ANNEX-1 Minutes of Meetings

1-1-1 Kickoff Meeting for Component 1-2 (15 February, 2012)

PROJECT FOR COMPREHENSIVE FLOOD MANAGEMENT PLAN FOR THE CHAO PHRAYA RIVER BASIN IN KINGDOM OF THAILAND

SKEMATIC DIAGRAM
LOCATION OF SUGGESTED CHANGE ON HYDROLOGICAL STATIONS

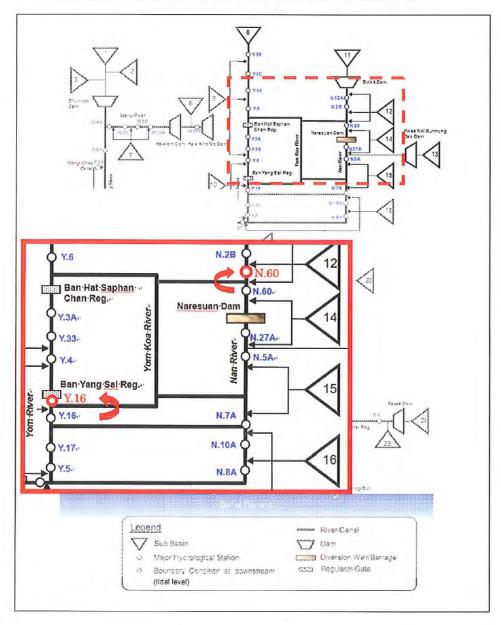
RID suggested that the location of hydrological stations of Y.16 and N. 60 be changed to the right locations in the schematic diagram shown in Figures 1.3.3, 1.6.1 and 1.6.2 in the meeting material. The suggested locations are shown in Annex 4. The Study Team agreed on the change.
